Maxtor Corporation
500 McCarthy Boulevard
Milpitas, CA 95035 USA

Subject: Proposal for SPI-5 for Ultra640 AAF receiver masks

The following is a proposal to modify SPI-5 clause 9.4.5 Paced transfers with precompensation disabled to include the requirements for Ultra640. All references in the following are to the draft standard SCSI Parallel Interface – 5 (SPI-5) revision 1. The changes required by this proposal are in **RED** font.

Figure 72 – **Fast-160** LVD paced transfer receiver mask for non-precompensated signals transitioning at the negotiated transfer period

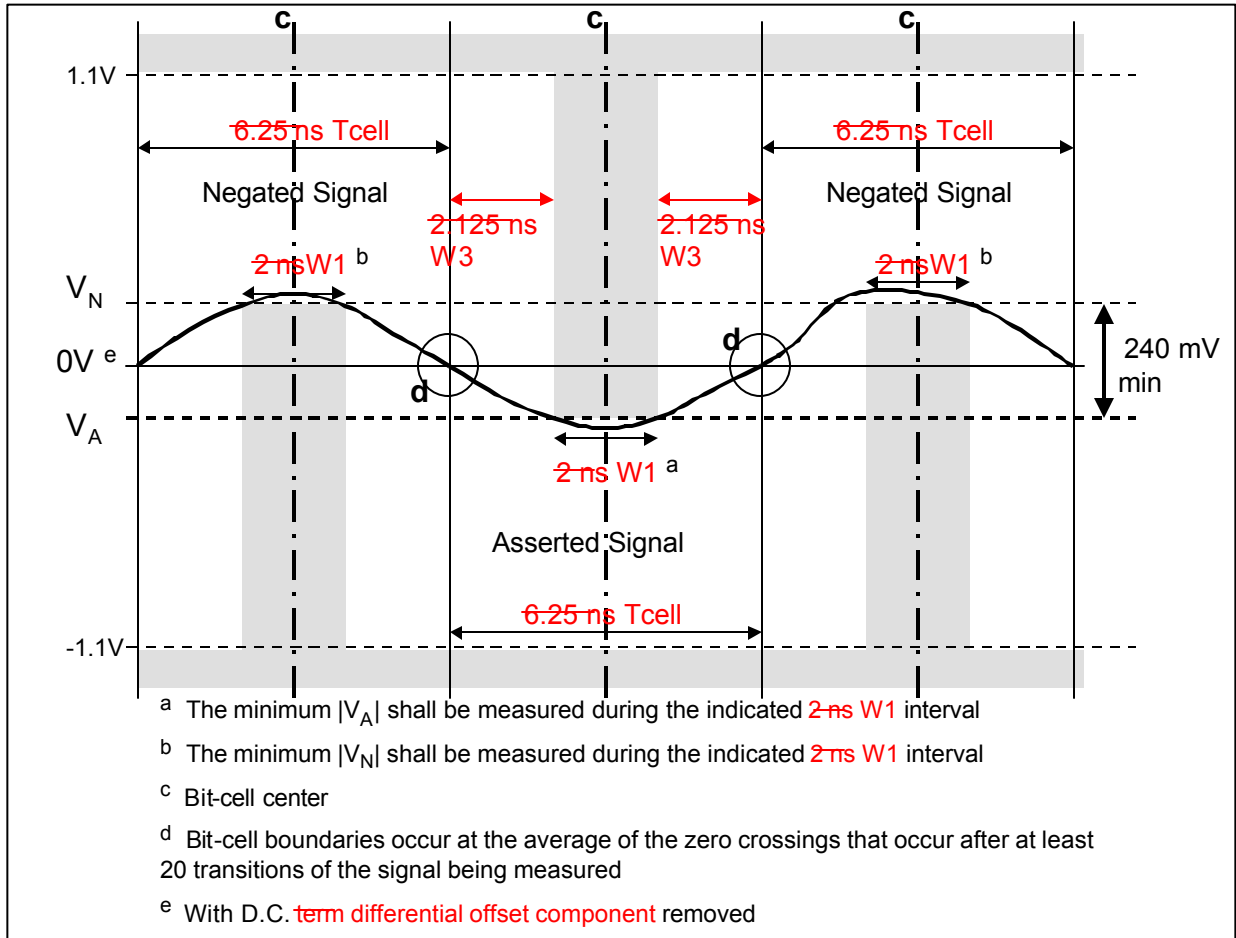
- a) V_A and V_N shall not be measured until at least 20 transitions have occurred on the signal being measured; and
- b) for fast-160, V_A and V_N shall be measured within a 2 ns interval centered on the assertion or negation pulse (see figure 72); and
- c) for fast-320, V_A and V_N shall be measured within a 1 ns interval centered on the assertion or negation pulse (see figure 72).

Receiver input eye masks in figures 72, 73, 74, 75 and 76 illustrate the requirements described in this subclause using the parameters in table x:

Parameter	Fast-160	Fast-320
Tcell	6,25 ns	3,125 ns
W1	2,0 ns	1,0 ns
W2	1,50 ns	0,75 ns
W3	2,125 ns	1,063 ns
W4	2,375 ns	1,188 ns

Figure 73 – ~~Fast-160~~ LVD paced transfer receiver mask non-precompensated minimum amplitude change

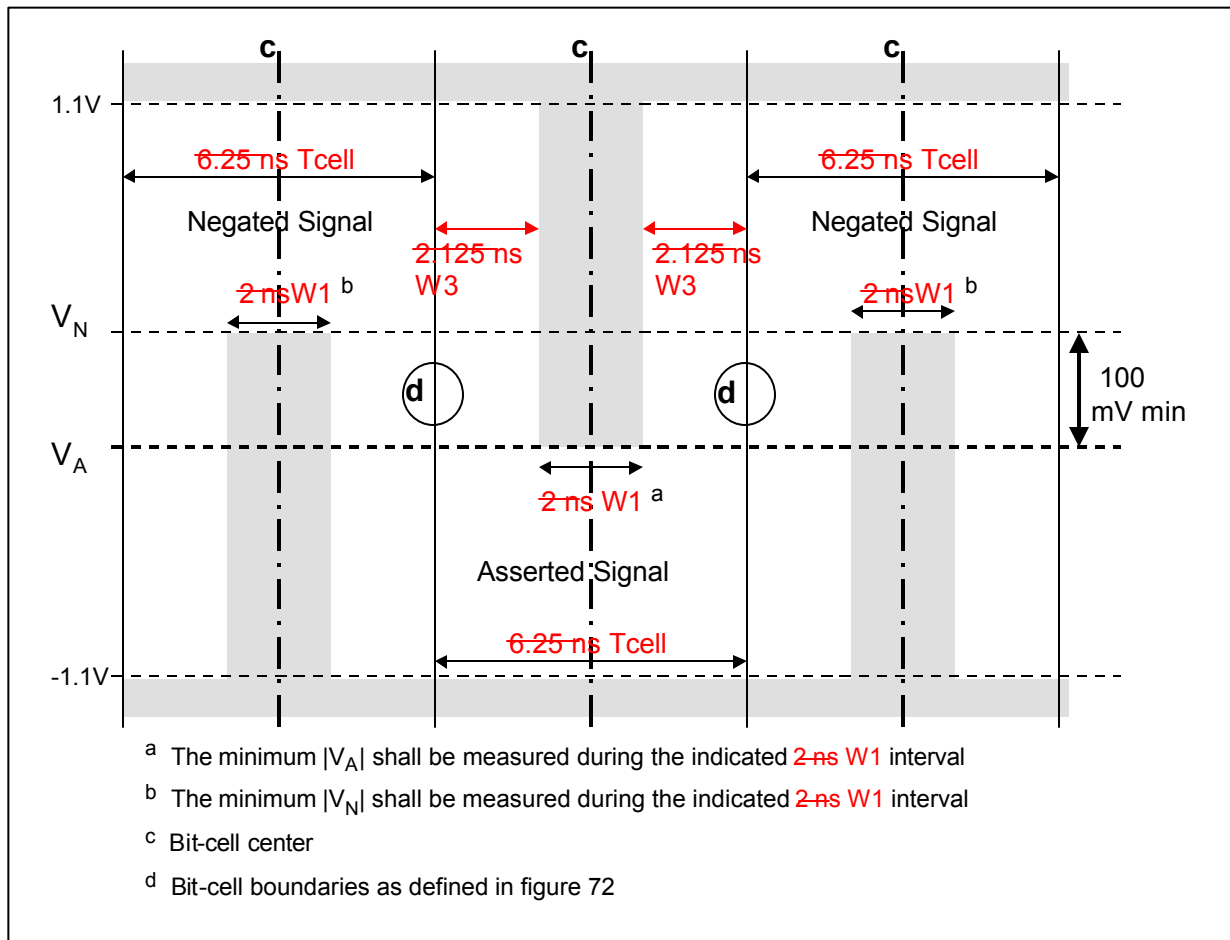
- a) A change in amplitude for all transitions shall be greater than 100 mV (see figure 73).
- b) The differential low frequency signal amplitude shall not exceed the following limits:

Figure 74 – ~~Fast-160~~ LVD paced transfer receiver mask non-precompensated non-clocking isolated assertion pulse

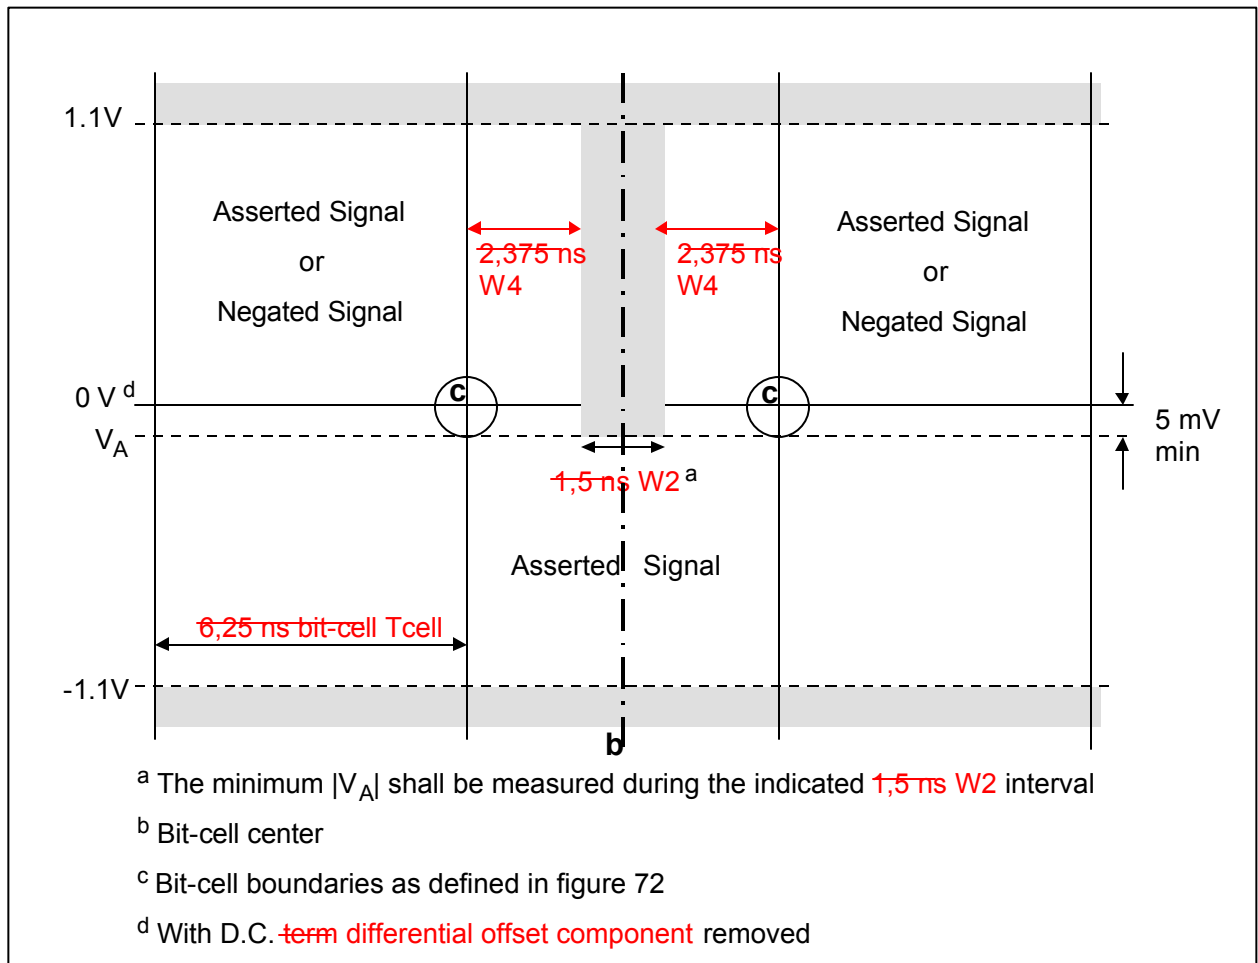
- e) All non-clocking signals shall meet the requirements defined for the isolated negation pulse receiver mask (see figure 75) and the isolated assertion pulse receiver mask (see figure 74).

Figure 76 – **Fast-160** LVD paced transfer eye mask non-precompensated non-clocking pulse

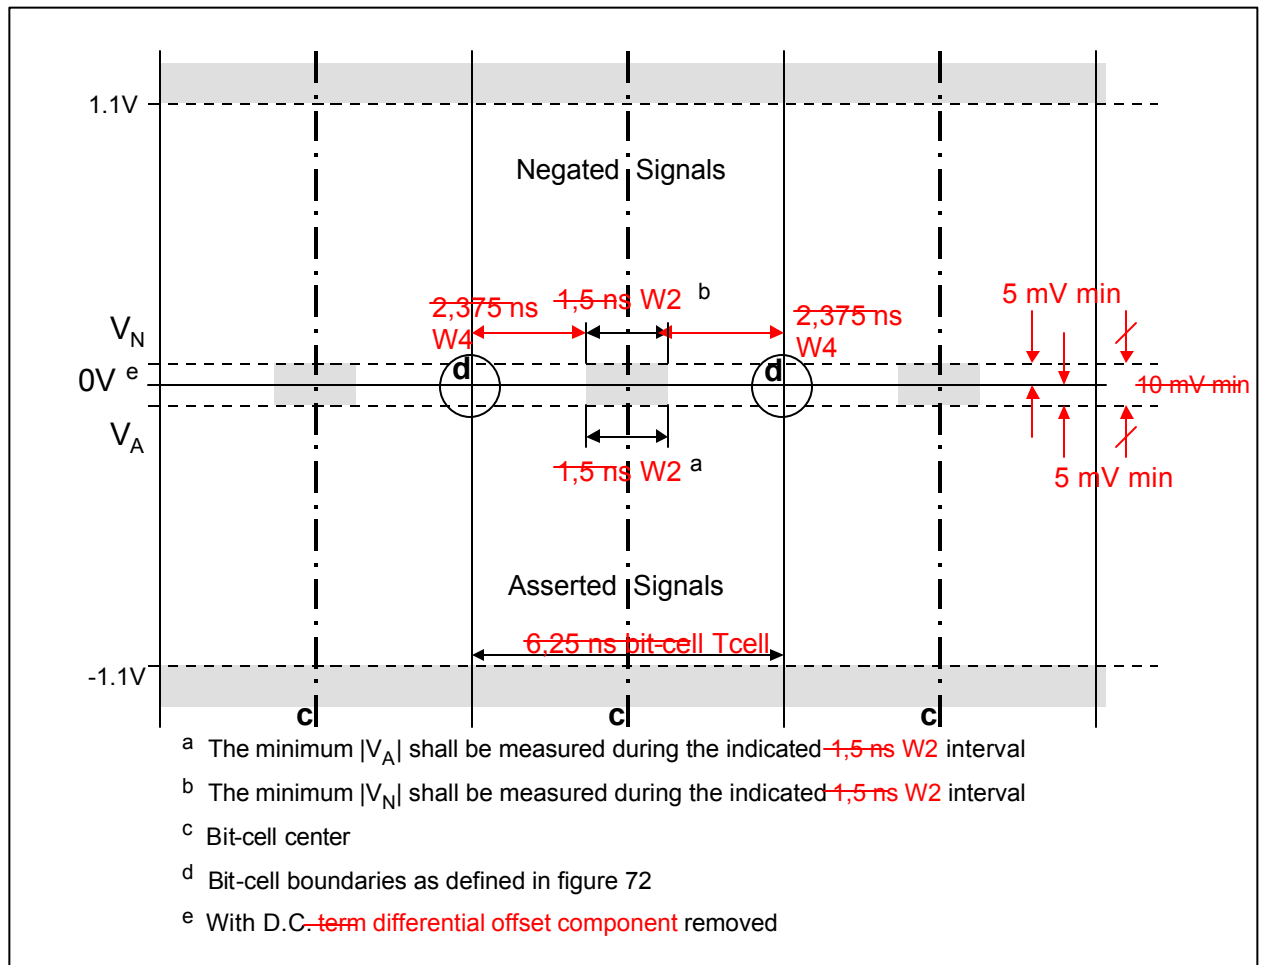
The eye diagram is formed by superimposing the waveforms of all bit cells of the input data pattern. **The For Fast-160**, the input data pattern shall be open for 1,5 ns centered on the bit-cell center, **and for Fast-320**, the input data pattern shall be open for 0,75 ns centered on the bit-cell center (see figure 76).
